Top Flite Giant P-51D Mustang ARF Technical Notice

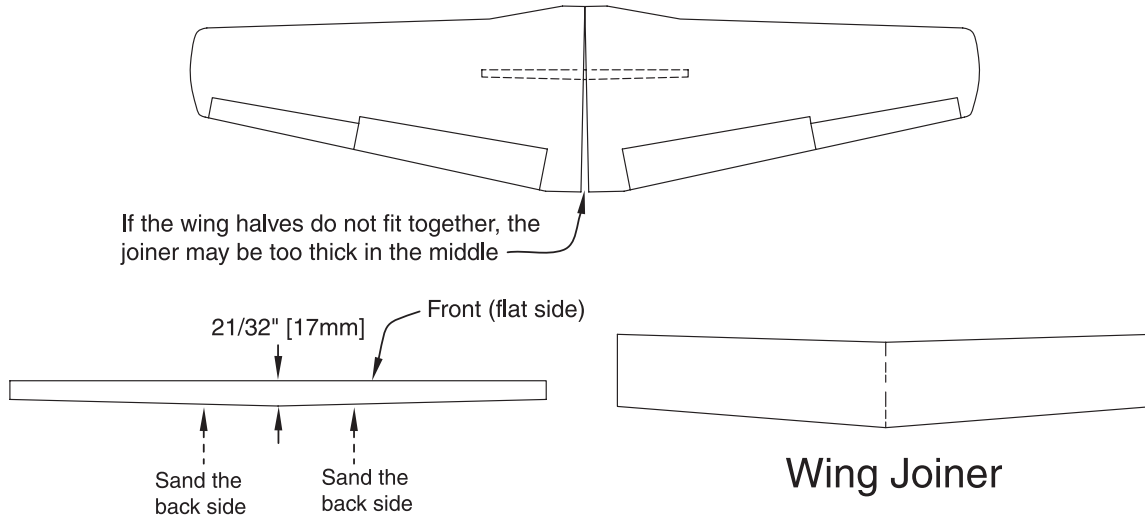
The **wing joiner** in a few kits may be too thick in the middle which could prevent the wings from fitting together all the way. The thickest part of the joiner should be 21/32" [17mm] in the middle. If, after test-fitting your wings together with the joiner, the wings will not completely come together, use a fine-point ballpoint pen to mark a centerline on the back of the joiner. Using the centerline as a guide, sand the **back side** of the joiner with coarse sandpaper until it is the correct thickness and you can get the wings to fit. **Note:** The instruction manual refers to plywood on the joiner, but current wing joiners are one-piece hardwood with no plywood lamination. The front of the joiner is the side that is flat.
